To: Development Permit Panel
From: Wayne Craig
Program Coordinator, Development
Date: September 4, 2012
File: DP 12-597695
Re: Application by Am-Pri Construction Ltd. for a Development Permit at 7691, 7711
and 7731 Bridge Street

Excerpt from the Minutes from
The Design Panel Meeting

Wednesday, May 9, 2012 – 4:00 p.m.
Rm. M.1.003
Richmond City Hall

Drawing Title:
LANDSCAPE PLAN

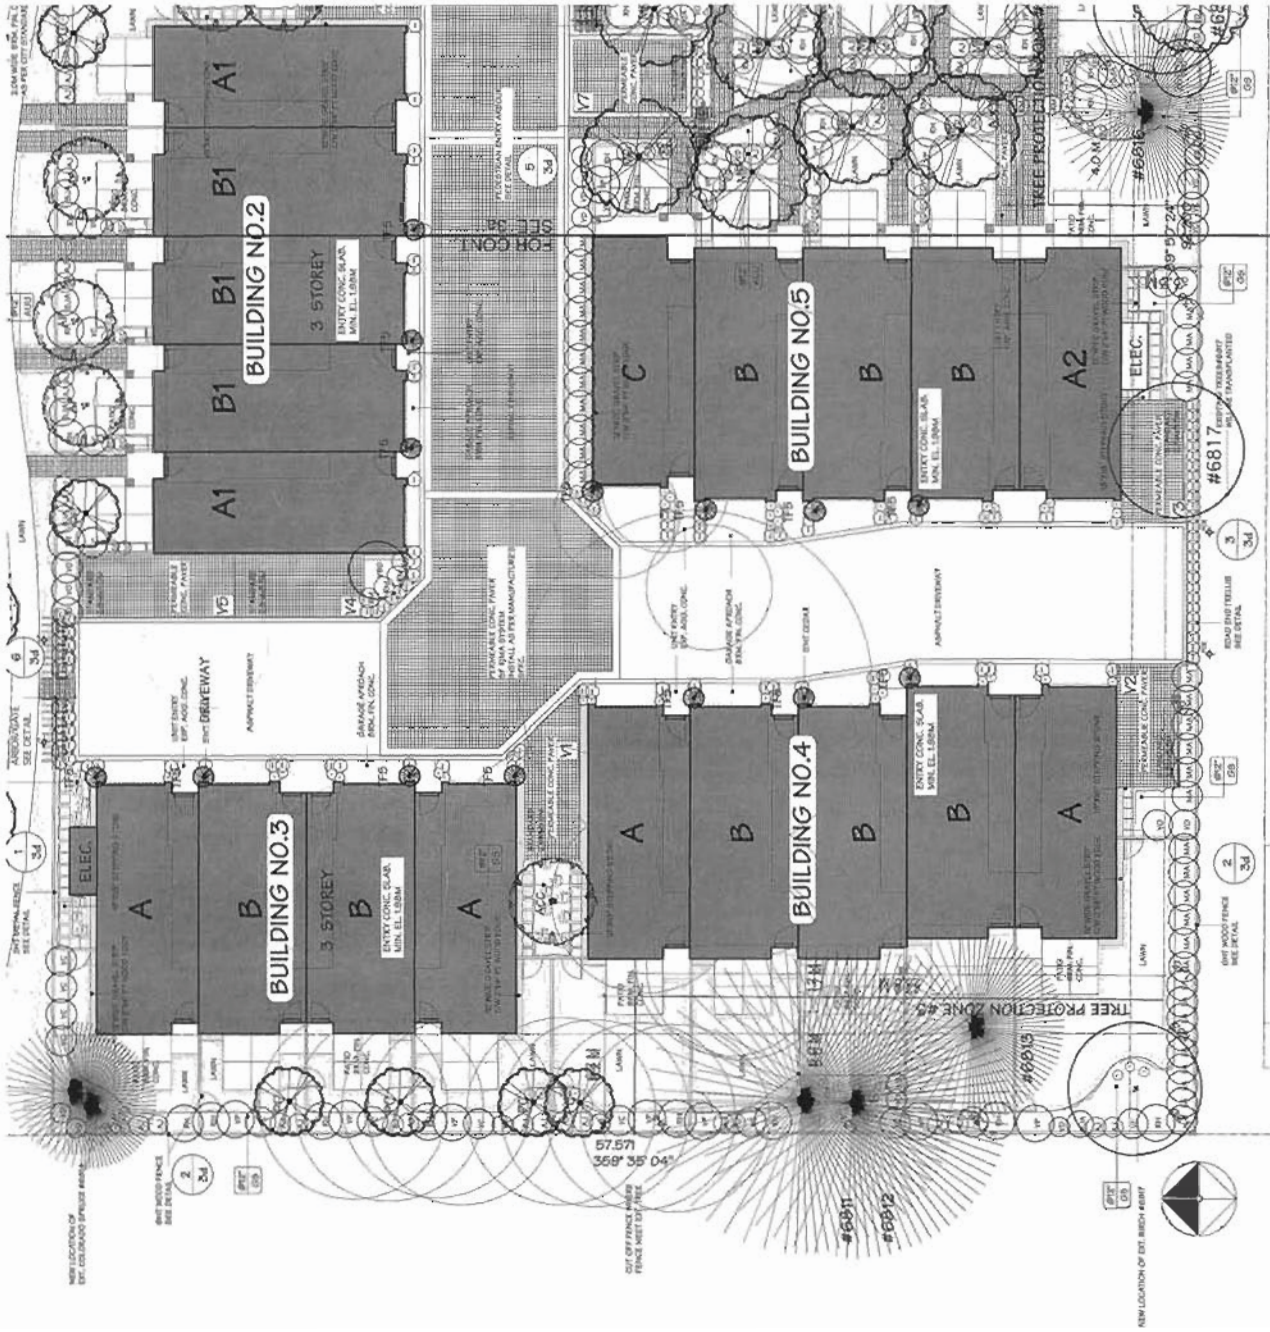
Investigate further the pedestrian experience on the public walkway at the northern edge of the property; neither straight nor curve; appears walk and not defined;

Project fits nicely into its context; nice to see the public walkway at the northern edge of the project; however, design development is needed with regard to the orientation of the pathway; should respond to the long and narrow condition of the ROW;

Extend permeable concrete pavers throughout the main drive aisle to introduce visual texture through the very narrow and long roadway;

Consider opportunity for a gate to provide connection from playground in the amenity area to the public ROW;

-The pedestrian public walkway has been redesigned to be more curvilinear. (L3.0)

-Pedestrian walkway has been redesigned to be more curvilinear and provide additional interest along its length.

-Permeable concrete pavers extended to run through the main internal drive way. (See L3.0)

-Gate provided from playground in amenity area to connect with public pedestrian walkway (See L3.0)

7 AMENITY ENTRANCE/MAIL KIOSK
SCALE: 1/4" = 1'-0"

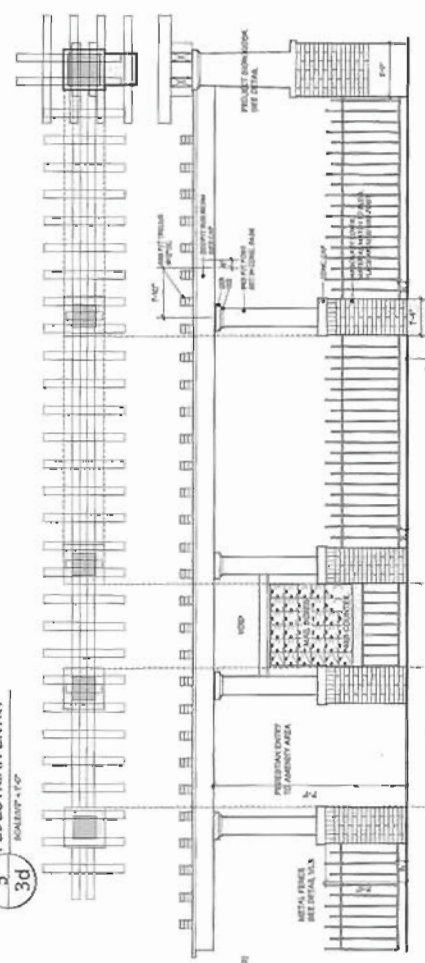
Unify mailbox, signage, gate to play area, and seating into one structure at the amenity area to provide opportunity for social interaction among residents;

-The mail box, sign, gate have been designed as one structure. However, the project sign and the gate to the play area remained as separate structures due to the distance between and the retention of tree #6793 in the amenity area.

CONVERTIBLE UNIT PLAN
SCALE: 1/8" = 1'-0"

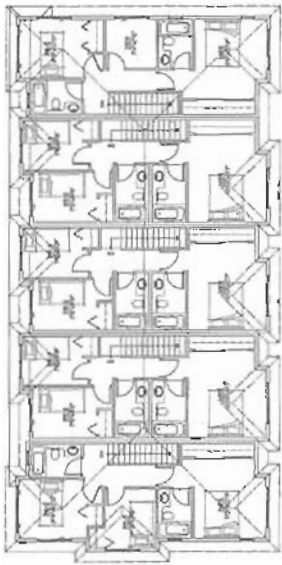
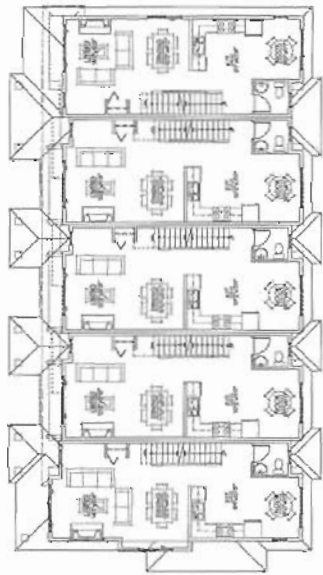
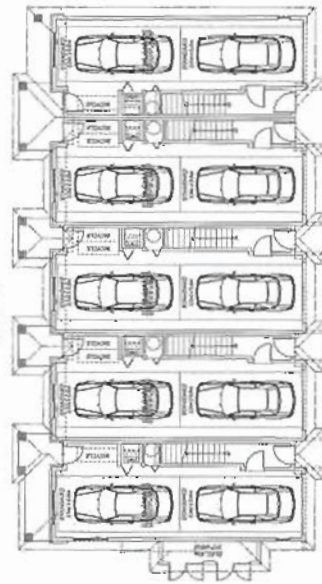
Per Plan#5, proposed ground floor and upper floor location of the potential vertical lift work well; however, proposed location of the potential vertical lift on the second floor is not appropriate as it is in the middle of a living room; consider moving it to a corner of a room;

Ensure that convertible washrooms will have enough circulation space;

-Vertical lift re-oriented vertically to provide access away from living room. (See A5.3)

-Convertible washroom showing dimensions to ensure there is circulation space. (See A5.3)
